FINAL DRAINAGE REPORT

**FALCON MEADOWS AT BENT GRASS
FILING NO. 4**

**PCD-ENGINEERING REVIEW COMMENTS
IN BLUE BOXES WITH BLUE TEXT**

PCD Filing No.: SF22XX

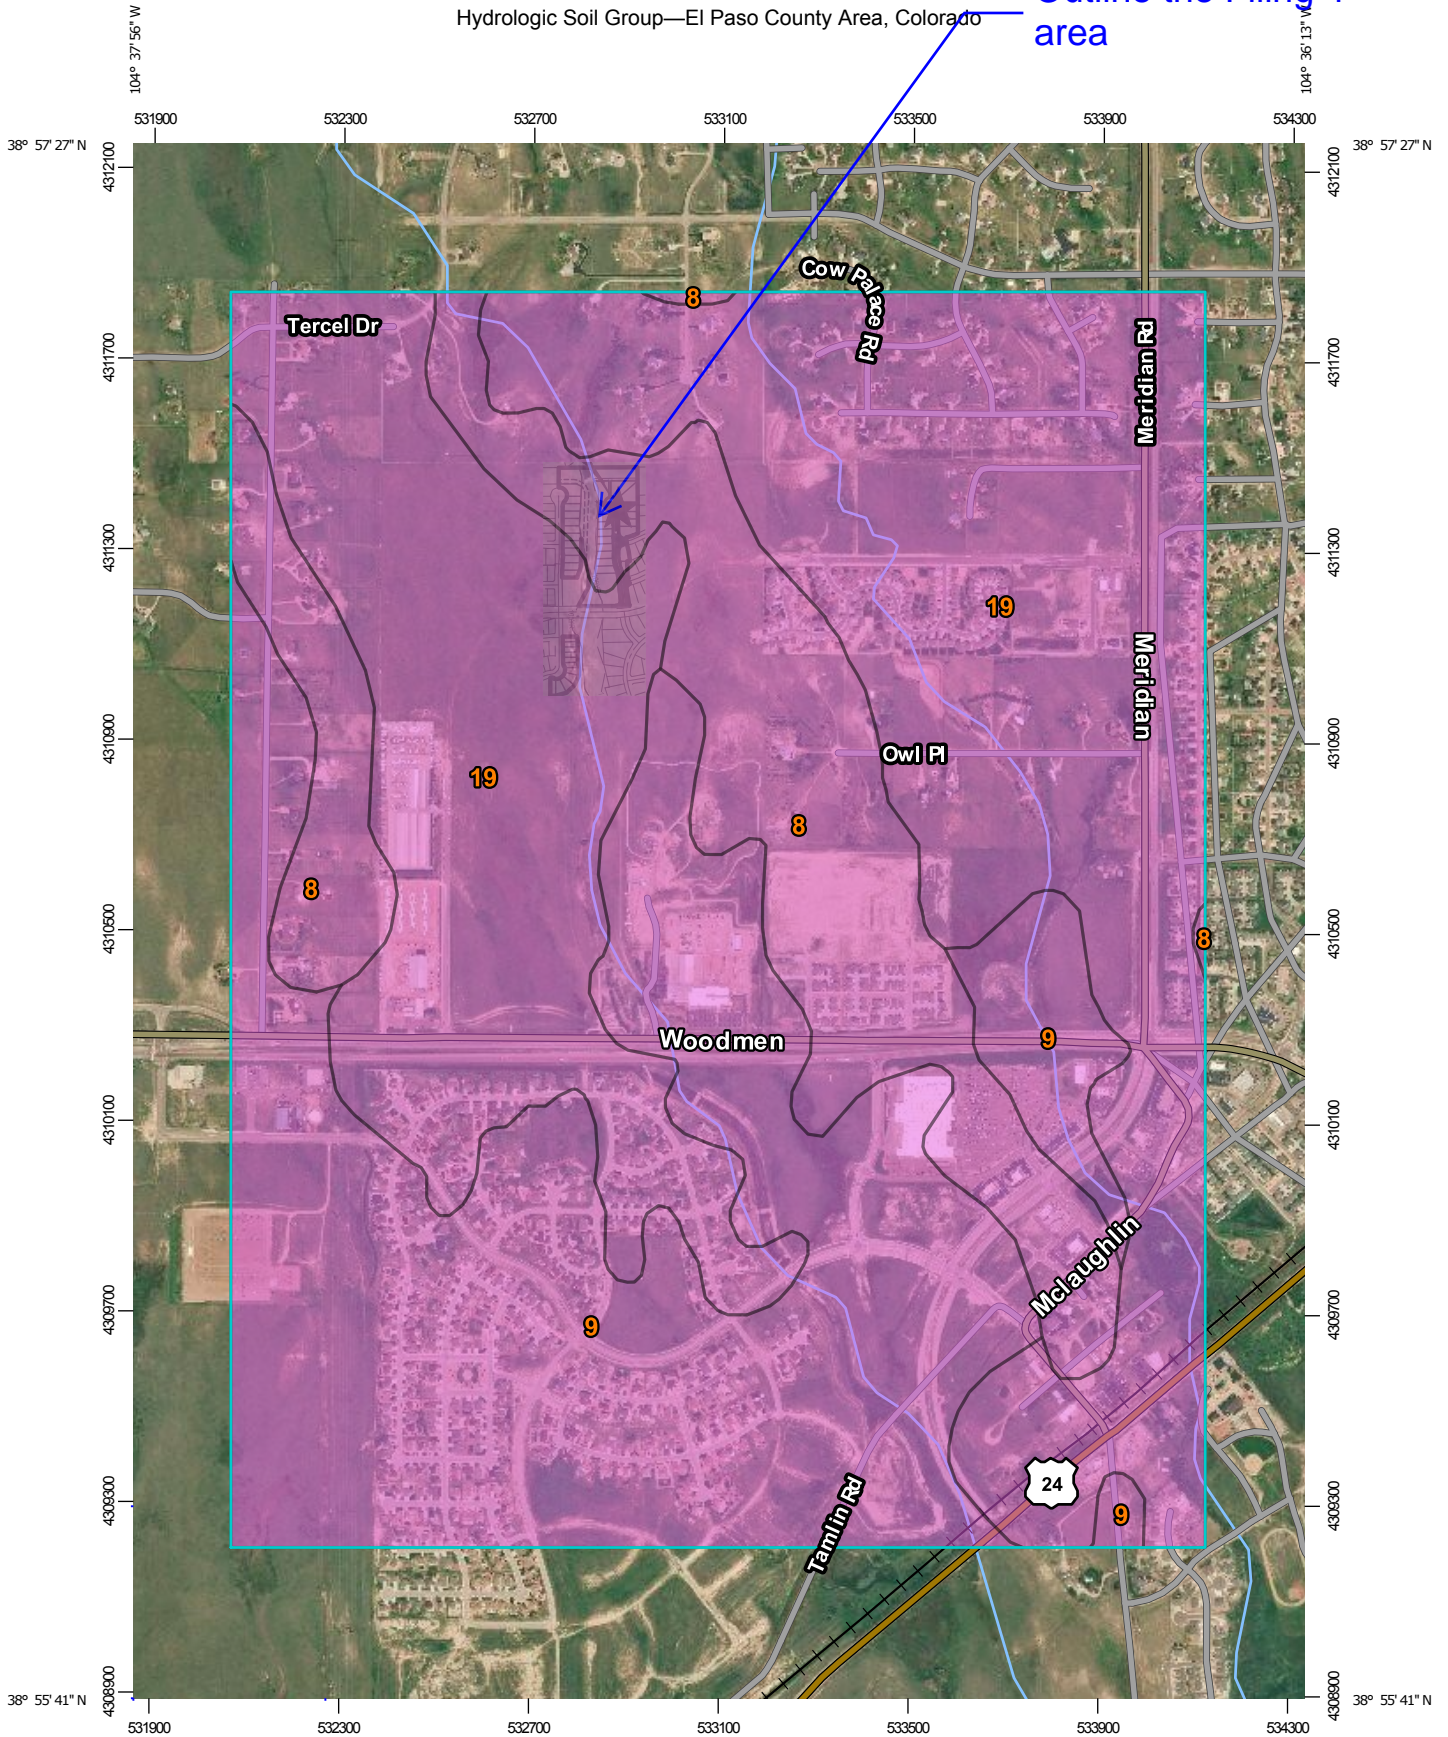
Outline the Filing 4 area
